ADDENDUM NO. <u>1</u>	DATED <u>11/5/2014</u>	ADDENDUM NO. _____	DATED _____
ADDENDUM NO. _____	DATED _____	ADDENDUM NO. _____	DATED _____

Number	Description
1	Revised Table of Contents; Add NTB No. 4329; NTB No. 5252 replaces NTB No. 5045; Add NTB Nos. 5264, & 5265; Add SP No. 907-810-4; Revised SP No. 907-824-1; Revised Bid Items; Revised or Added Plan Sheet No. 8001; Amendment EBS Download Required.

BR-0015-01(120) / 106487301

### PROJECT: BR-0015-01(120) / 106487301 – Adams County

PROPOSED REPAIR STRINGER CONNECTION AT CONTRACTION JOINT

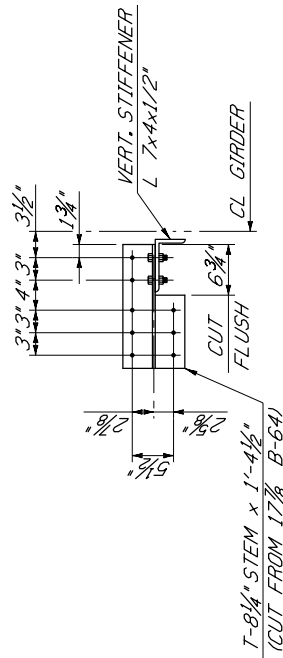
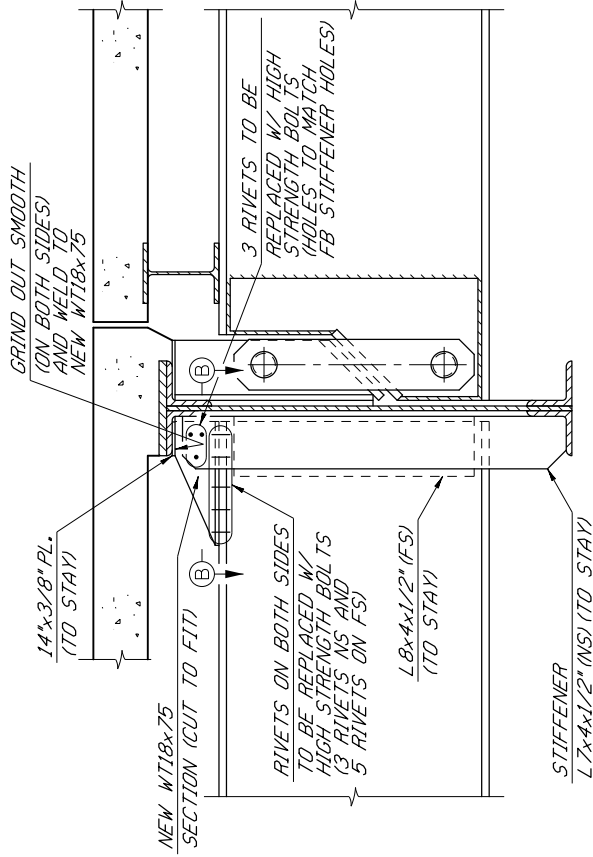
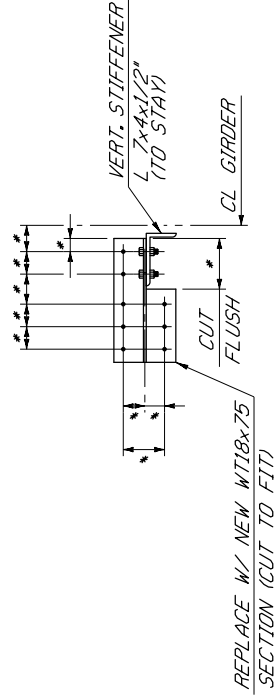
Bidders are advised that the attached drawing and photos are to be referenced when repairing the knee braces on this project.

\* NEW HOLES IN WT SECTION NEED TO MATCH FB TOP FLANGE HOLES

**907-810.03.1--Installation.** Repair procedure shall include removing existing knee brace connecting floorbeam and stringer top flanges. Welding along the top of existing knee brace web shall be grinded smooth on both sides. Rivets connecting knee brace to floorbeam vertical stiffener and stringer top flange shall be removed.

Existing knee brace shall be replaced with new WT18X75 section which shall be cut to fit. The new knee brace shall be connected to vertical stiffener and stringer top flange using high strength bolts. New bolt holes shall match existing holes in the vertical stiffener and the stringer top flange. Bolts shall be of equal diameter as existing rivets. The Notice To Bidders entitled "Knee Braces" shall be used as a guide and Contractor shall verify all the dimensions in the field. No traffic shall be on the lane while knee brace is being removed.
